**BEFORE THE ZONING COMMISSION
FOR THE DISTRICT OF COLUMBIA**

**Department of General Services
Metropolitan Police Department 7th District Headquarters**

**Application for a Consolidated Planned Unit Development and
Related Zoning Map Amendment from RA-1 to RA-2**

**ZONING COMMISSION CASE NO. 25-20
Applicant's Prehearing Statement
April 30, 2026**

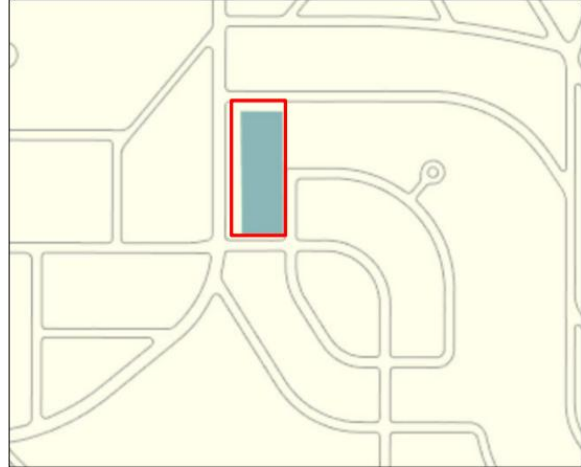
In the Setdown Report, OP requested that the Applicant provide a “phasing plan for temporary parking arrangements through the redevelopment of the site,” explaining that such information is needed to ensure parking impacts are mitigated during phased construction and that the MPD facility needs to continue meeting parking needs while operations remain ongoing. *See* Ex. [11](#), p. 2. At the Setdown Meeting, the Commission also requested this information.

In direct response, the Applicant requests flexibility to allow temporary off-site accessory parking on the Interim Parking Site. The Interim Parking Site is a vacant parcel owned by the

District and located directly east of the Property, across the unimproved portion of Knox Street, SE. The Interim Parking Site is zoned R-3 and lies outside the boundaries of the PUD site.² The location and zoning of the Interim Parking Site are shown below in the accompanying aerial view and excerpt of the Zoning Map:
